Product Change Notification					PCN OG Cover Change of product design		
owner	creation date	release date	released by	change order	rev	page	
lutzjo	26.01.2023	03.04.2023	schulejo		A	1 of 2	D10-070-948

Cover for Holder OG (Clip) 5x20, OG (Halter) 5x20, UH, UHB

Current product appearance	New product appearance

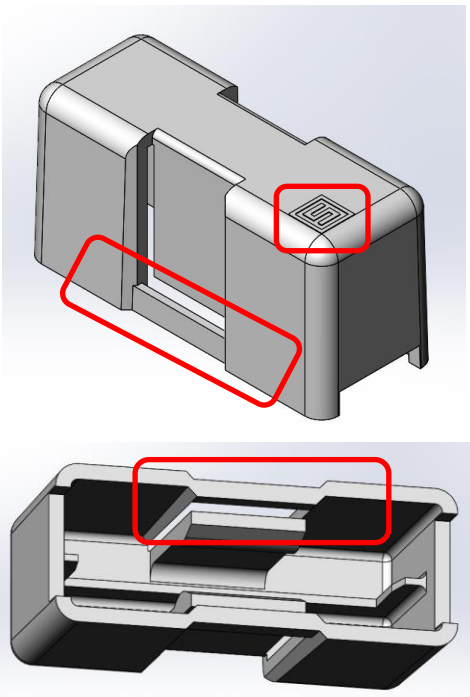
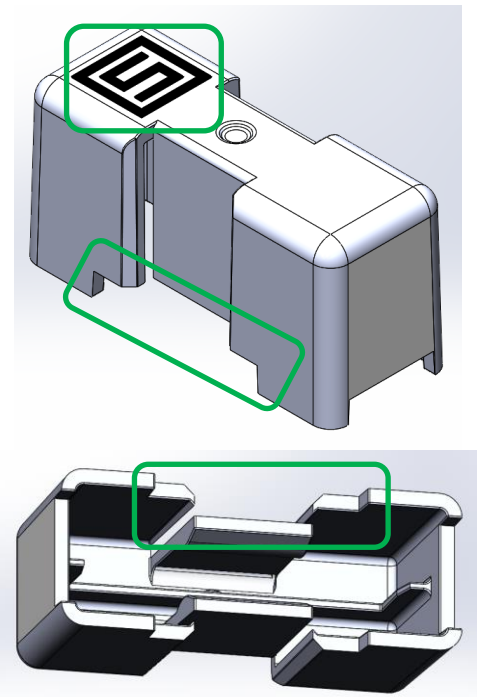
- Outside dimensions remain the same
- Position and size of SCHURTER logo changed
- Bridge on both sides removed

- Production process improvement
- Improved moulding process to avoid flow lines
- Improved legibility of the product markings

<input checked="" type="checkbox"/>	Form	Consider new product design and new position of product marking. Outside dimensions remain the same.
<input type="checkbox"/>	Fit	
<input type="checkbox"/>	Function	
<input checked="" type="checkbox"/>	Manufacturing	No action required, new moulding tool
<input type="checkbox"/>	Label	
<input type="checkbox"/>	Packaging
